STAFF RECOMMENDATION
2517 Blair Boulevard
June 20, 2018

Application: New construction—addition to outbuilding
District: Hillsboro-West End Neighborhood Conservation Zoning Overlay
Council District: 18
Map and Parcel Number: 10415002700
Applicant: Blaine Bonadies
Project Lead: Melissa Baldock, melissa.baldock@nashville.gov

Figure 2. The existing outbuilding

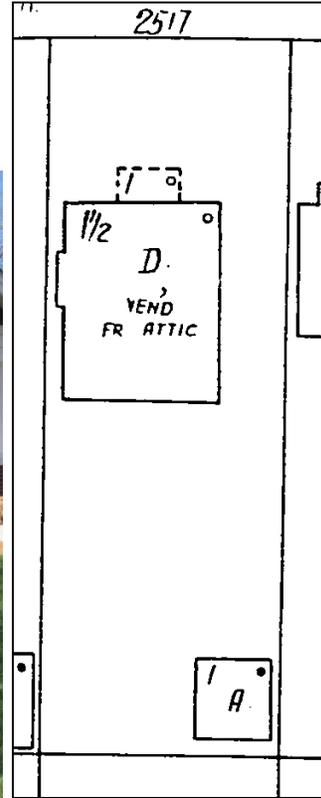
outbuilding is seven hundred and forty-eight square feet (748 sq. ft.). It does not meet base zoning setback on the left side. The existing structure is just one foot (1') from the left side property line towards the front and is approximately two feet, eight inches (2'8") from the side property line at its rear. Staff finds that increasing the height of the outbuilding from one-story to one-and-a-half-stories and from approximately sixteen feet (16') tall to twenty-two feet (22') tall increases the non-conformity of the setbacks and is not appropriate. Staff therefore finds that the project does not meet Section II.B.h.2 of the design guidelines.

The addition to the outbuilding will increase the ridge height from sixteen feet (16') to twenty-two feet (22'), which approximates the height of the house from the foundation line. The site slopes significantly, so staff and the applicant took measurements from the foundation line for the historic house and from grade for the garage. While staff finds that the proposed ridge and eave heights meet Section II.B.1.h. of the design guidelines, staff finds that increasing the massing of the existing outbuilding to be inappropriate since the outbuilding does not meet the base zoning setbacks.

site plan
scale: 1" = 20'

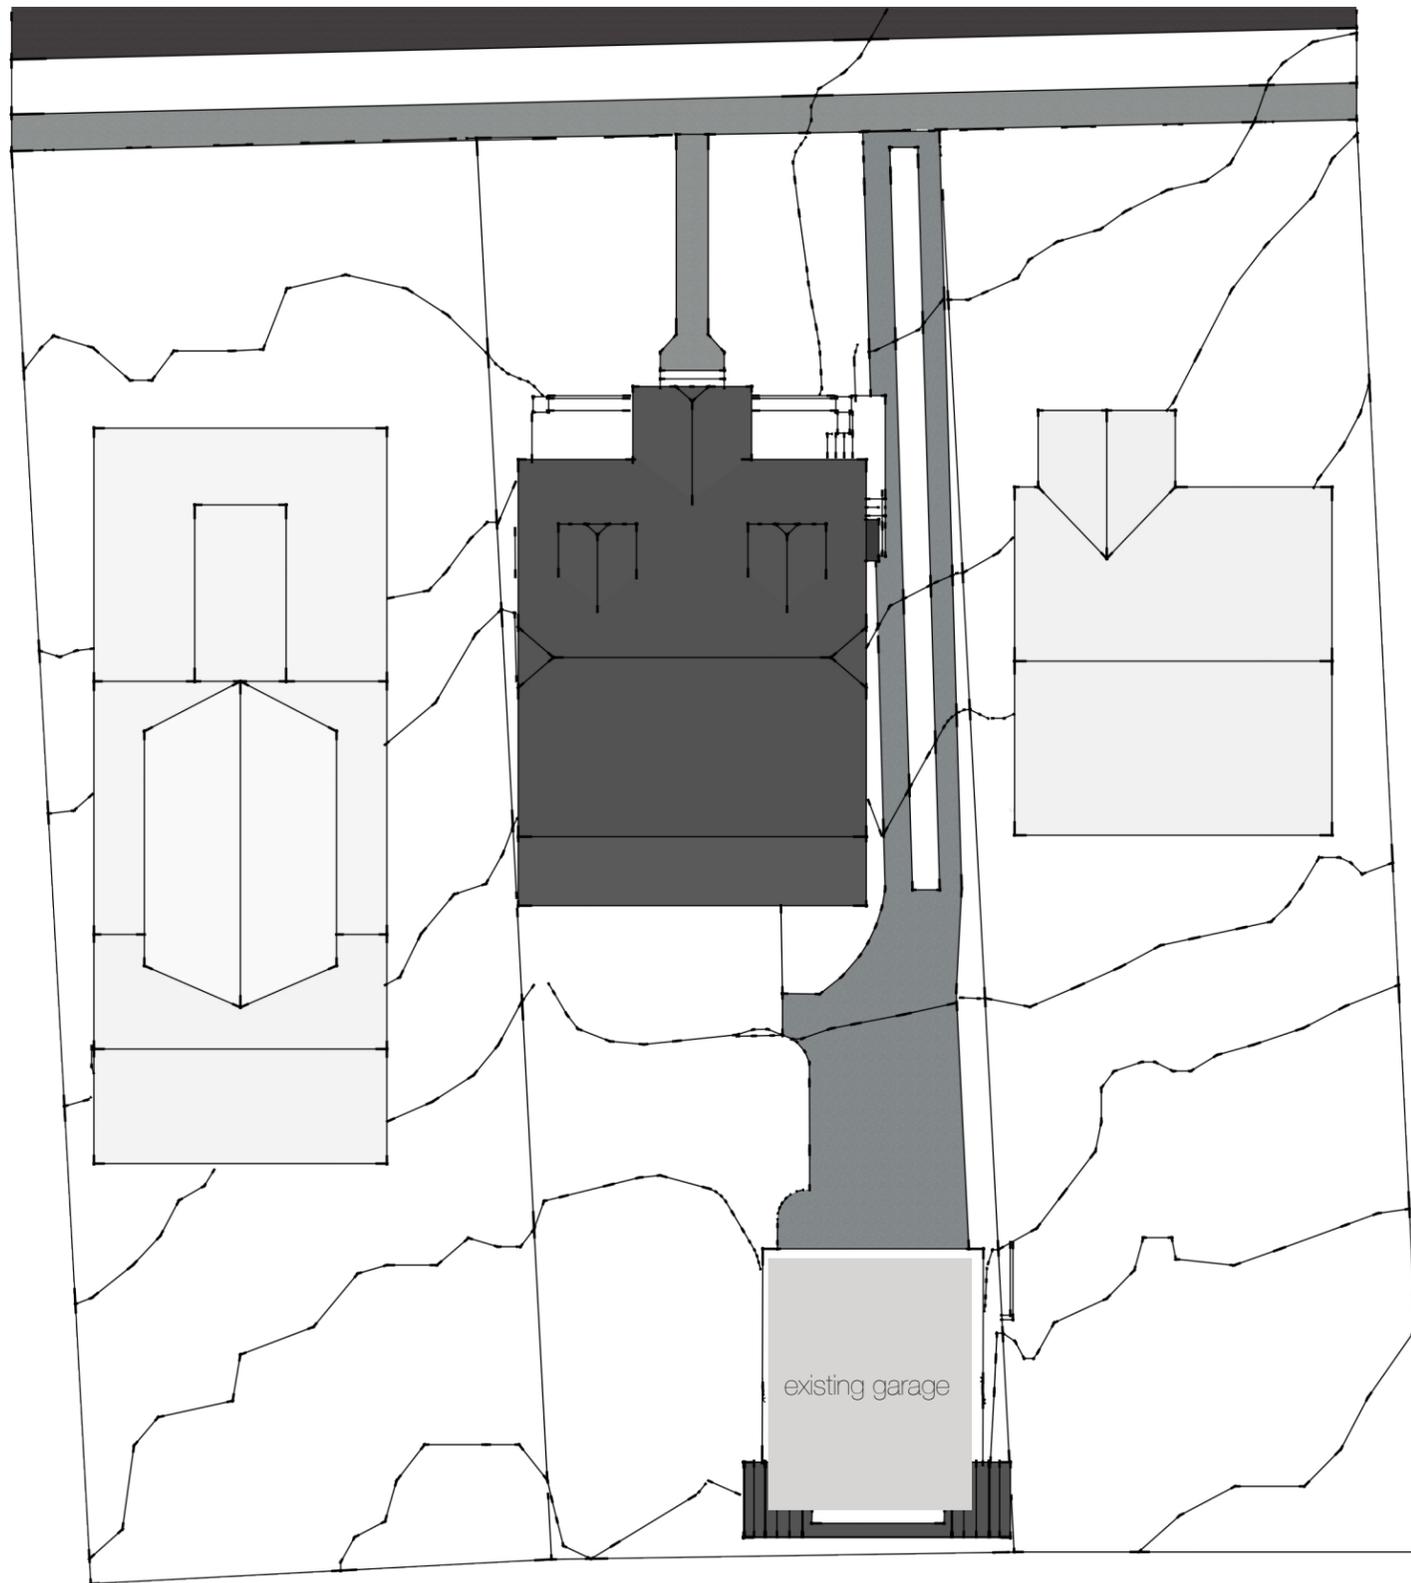
MINIMUM	PROPOSED
Building located towards rear of lot	n/a	Yes
Space between principal building and DADU/Garage	20’	35’
Rear setback	3’	3’
L side setback**	5’	1’ *
R side setback**	5’	23’
How is the building accessed?	From the alley or existing curb cut	Existing curb cut

* Base zoning requires a five foot (5’) side setback when the outbuilding’s footprint is larger than seven hundred and square feet (700 sq. ft.) like this one. The existing
